Belmont Public Library

Library Building Committee Meeting #2
January 17, 2023

Design Update Agenda

Ground Floor Plan

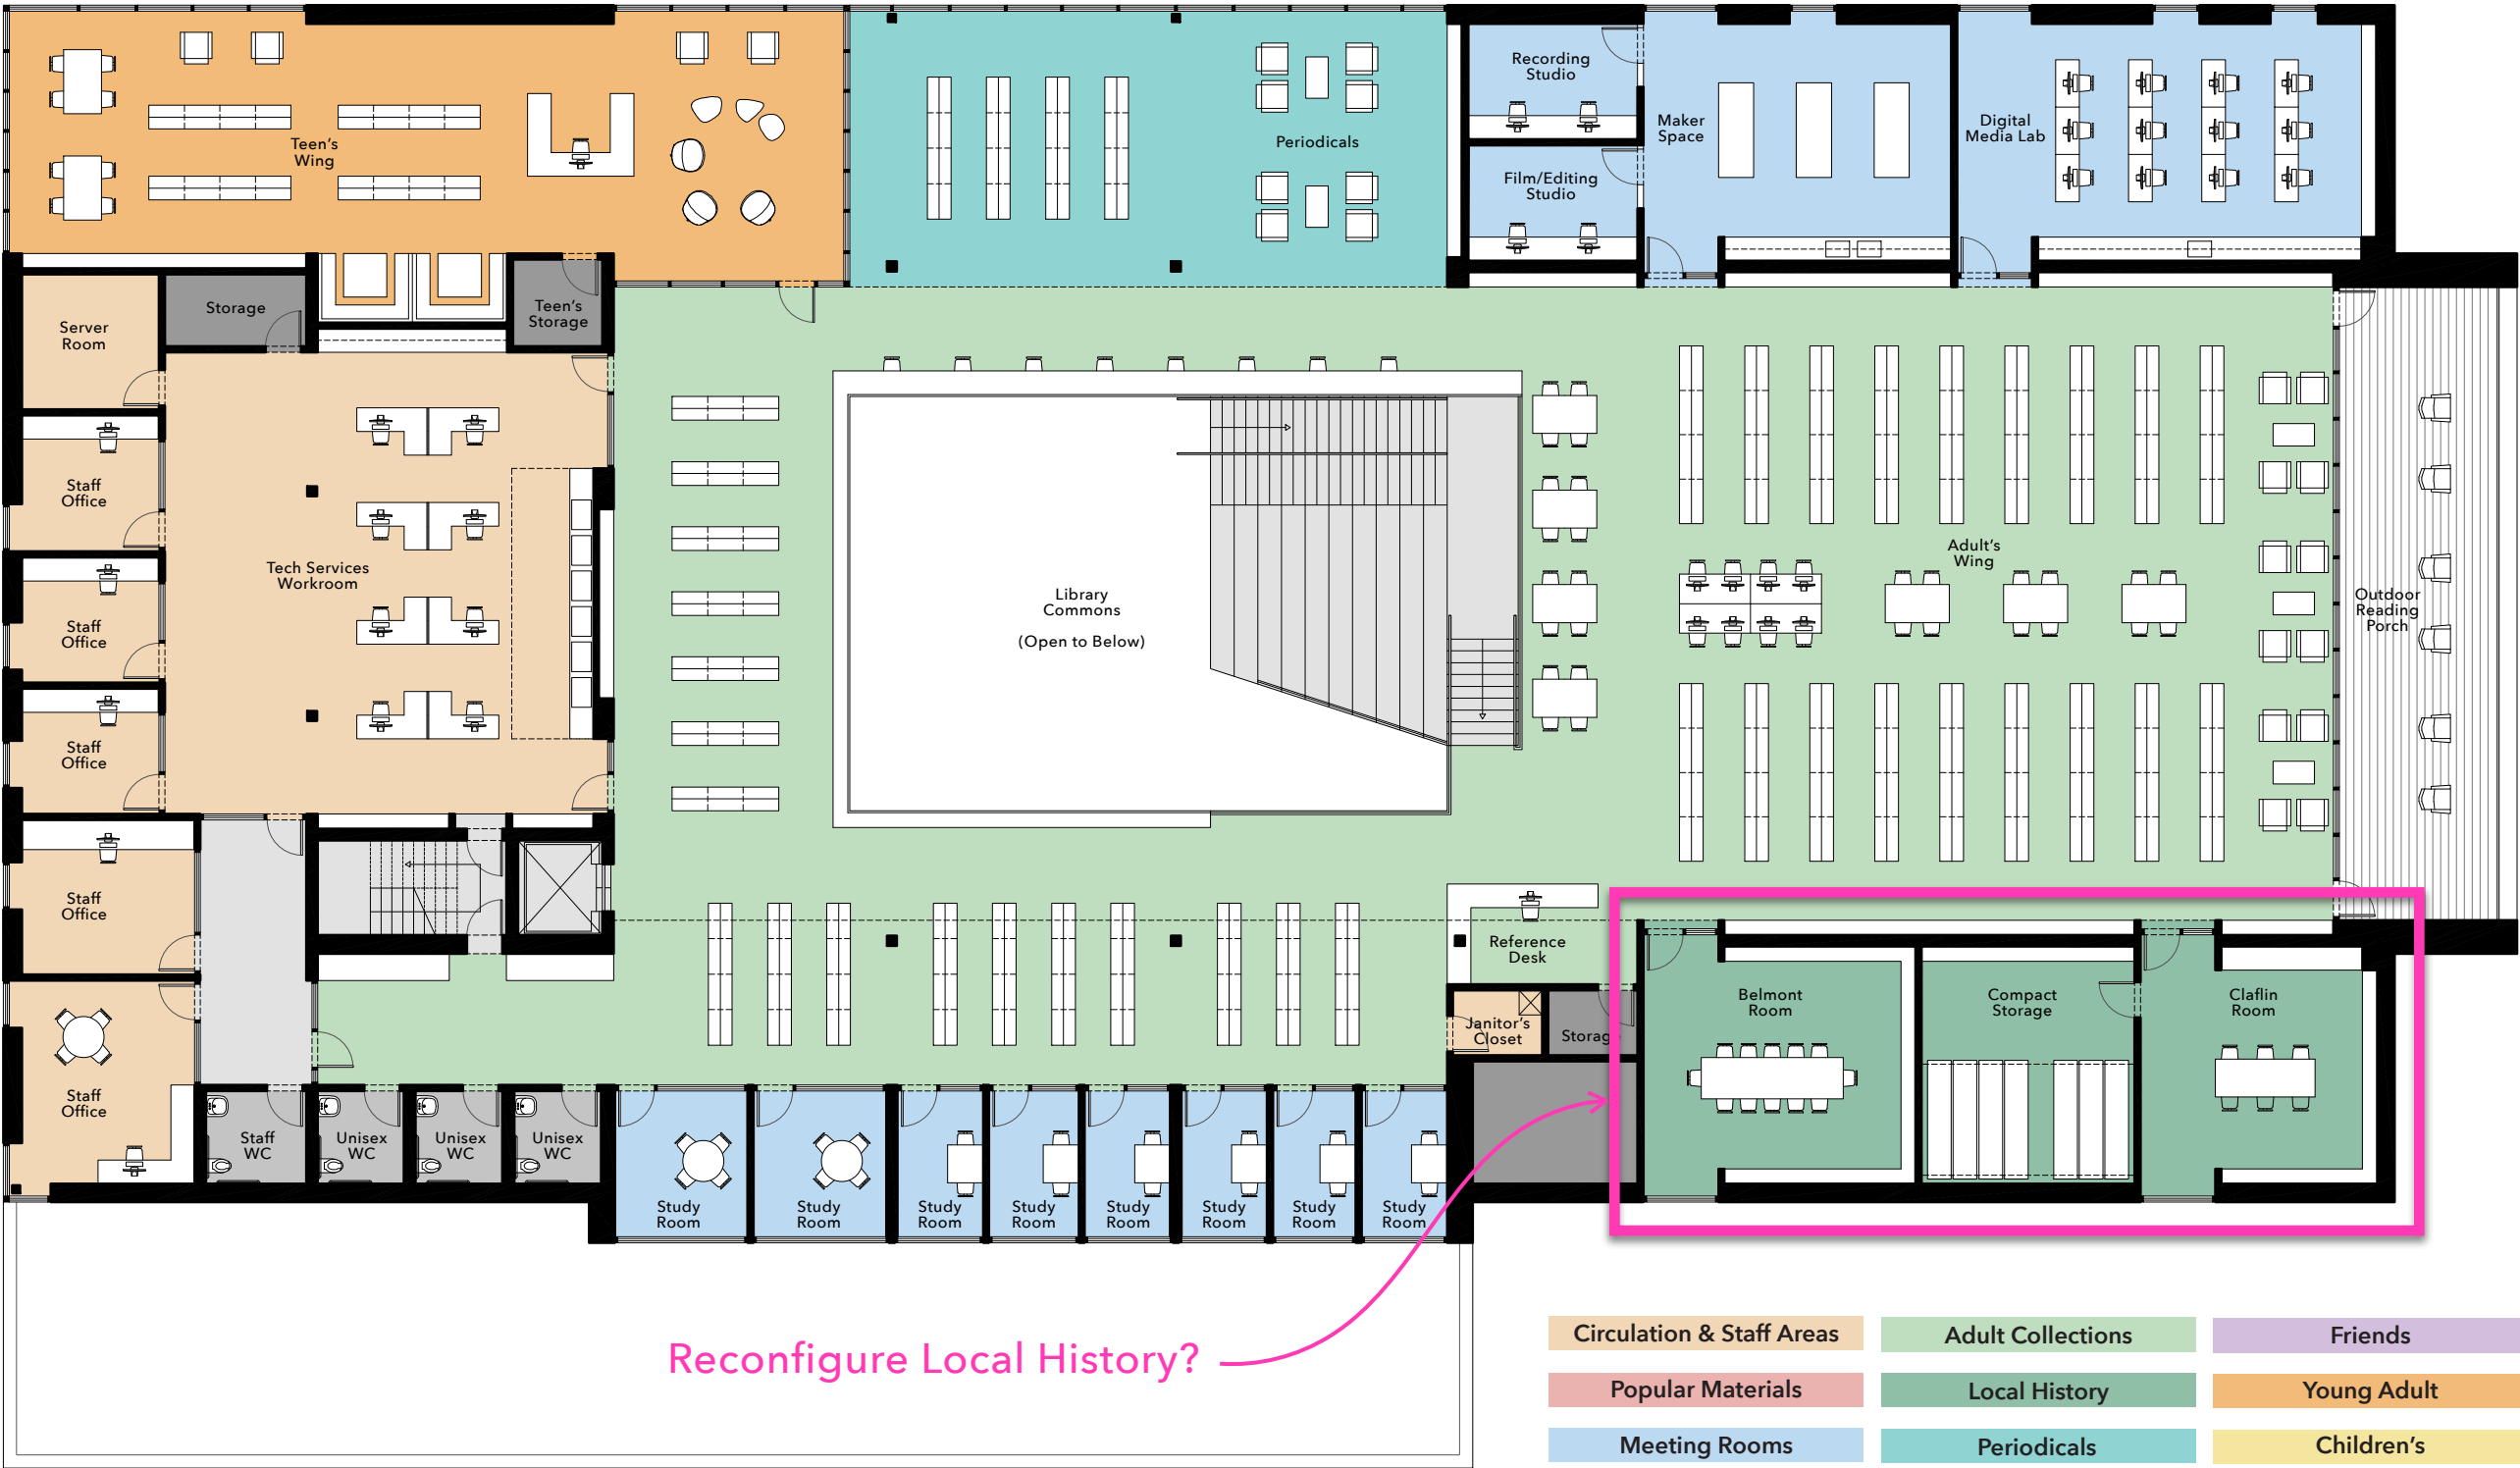
Revise Stair?
